Date: October 7, 2020
To: West Linn Planning Commission
From: Jennifer Arnold, Associate Planner
Subject: Written Testimony: SUB-20-01 – 6-Lot Subdivision at 4096 Cornwall Street

Public Testimony: Willow Ridge Geologic and Hydrologic Risk Parameters

Willow Ridge Proposed Development 4096 Cornwall St., West Linn, OR Tax Lot: 6300

Rock Fall Risk

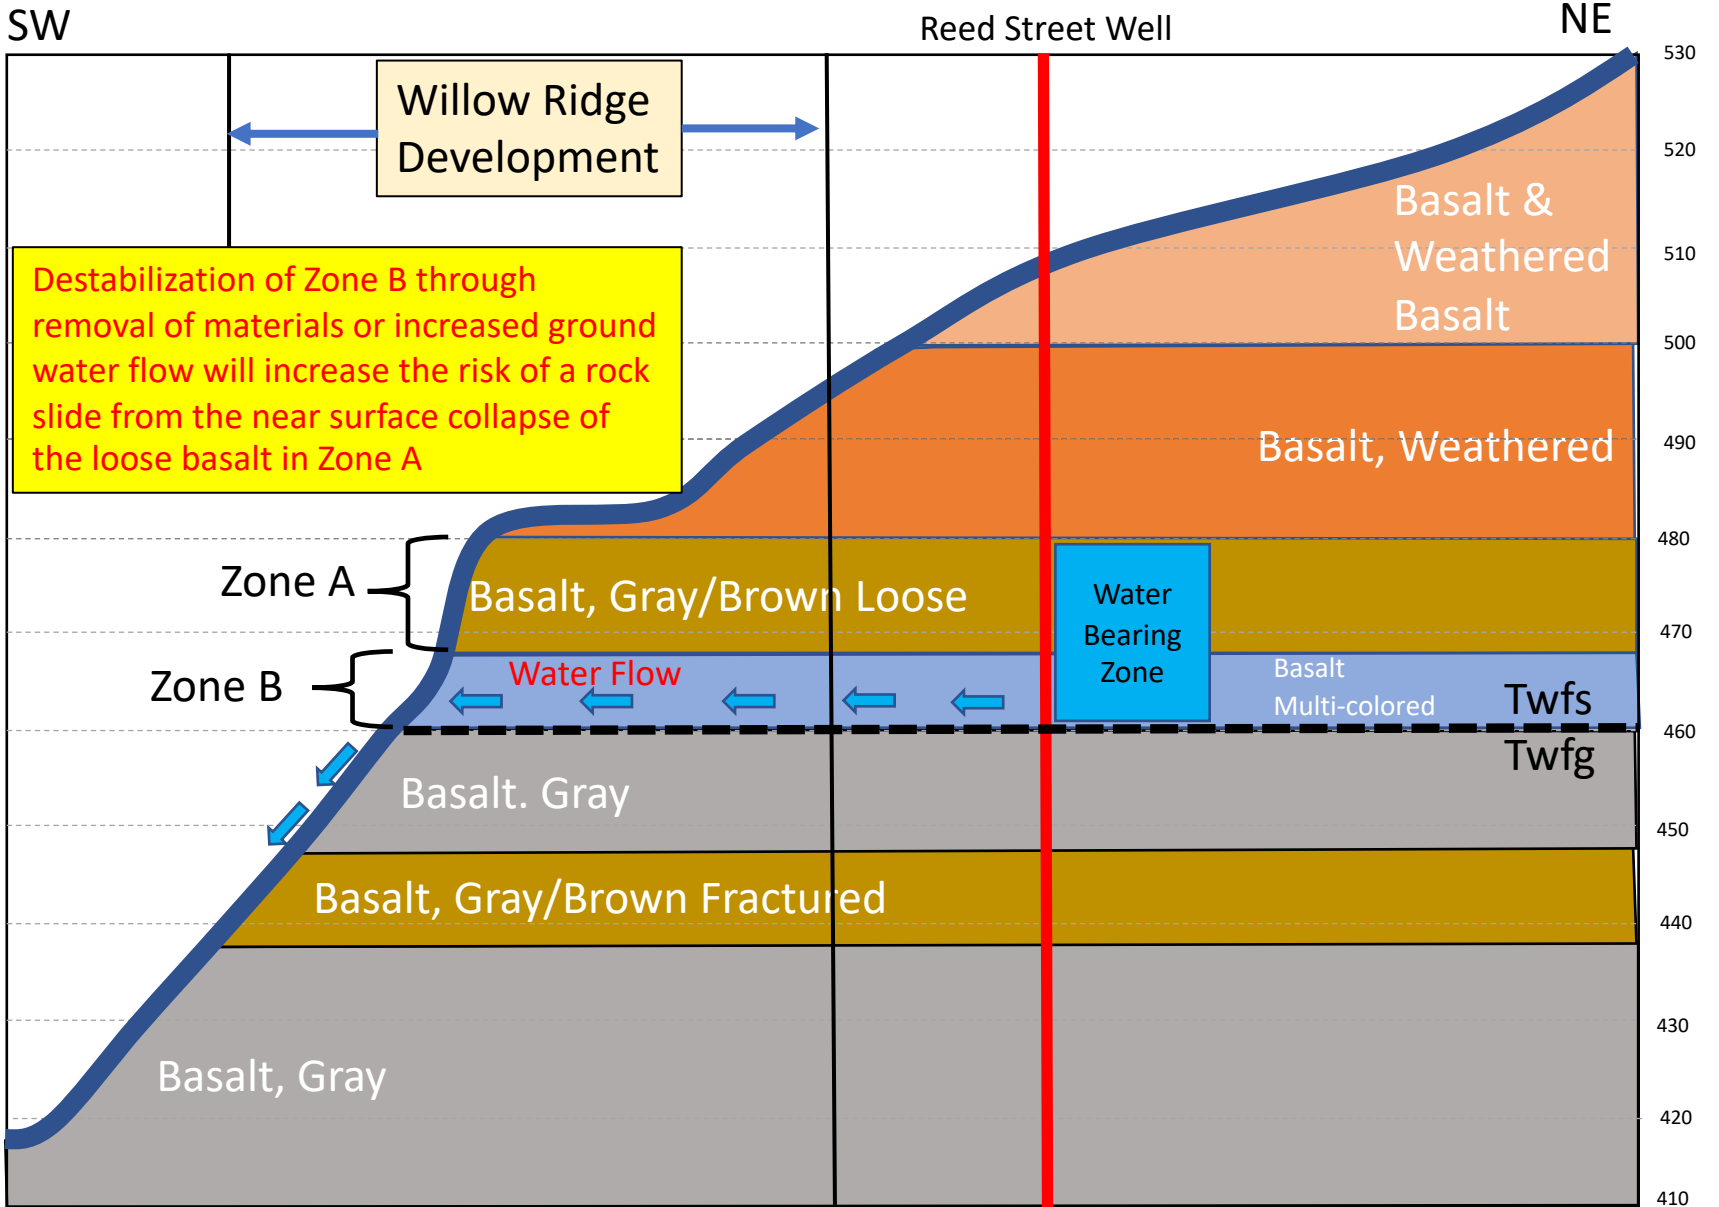
Based on the geology of the Reed Street Well the steepest portions of the existing slope are composed of loose, gray/brown basalt. The next zone of gray/brown basalt approximately 20 feet deeper is described as fractured. Loose or fractured basalt indicates a degree of disaggregation in the rock unit. Removal of structural support at the base of this unit on the slope could result in near surface collapse of the overlying unit and disaggregation of the mass into a shallow rockslide.

The steepest portions of the Willow Ridge slopes between 467 feet and 481 feet ASL are interpreted to be composed of loose, gray/brown basalt based on the Reed Street Well. The application does not specifically address this zone or measures needed to ensure that, during construction, slope stability will be maintained to prevent shallow rockslides.
